Maple and Poplar_North Block

Proposed Floor Plans

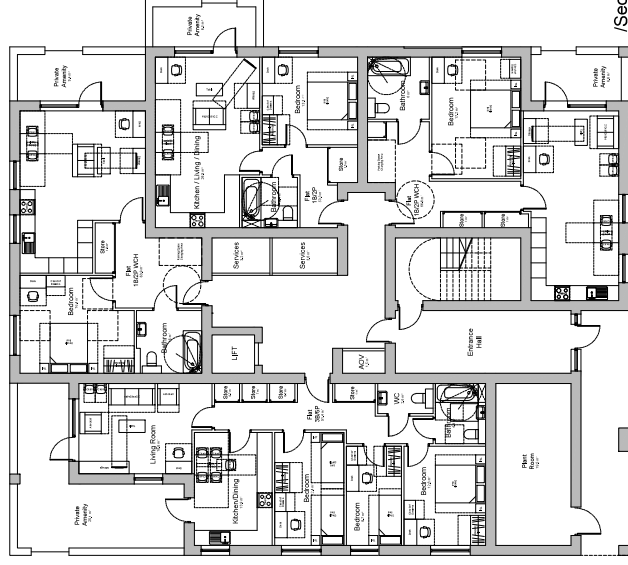
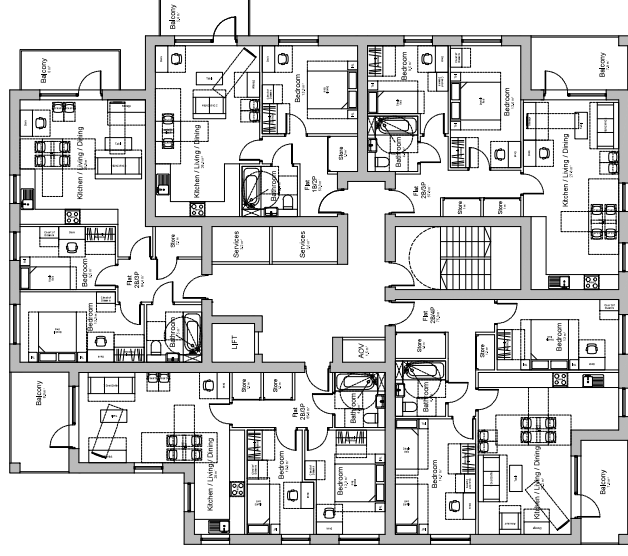
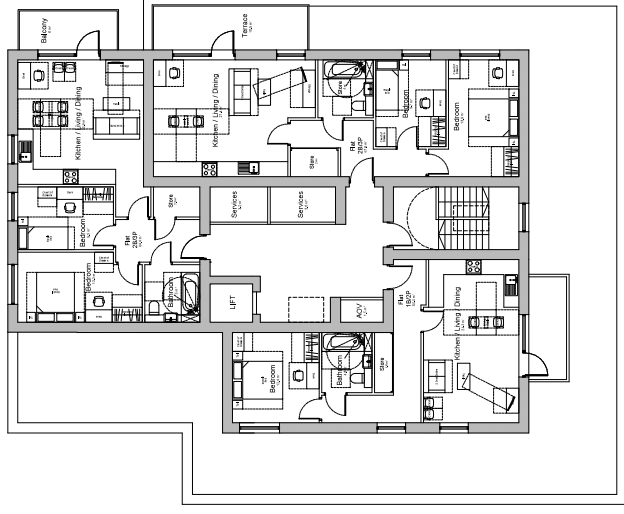
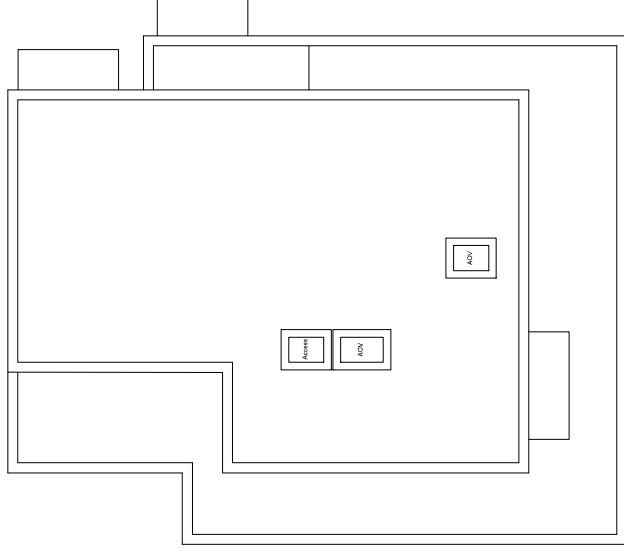
30/01/2023- Revision No.04
Kitchen layout for M4(3) units adjusted as per Access Officer comments.
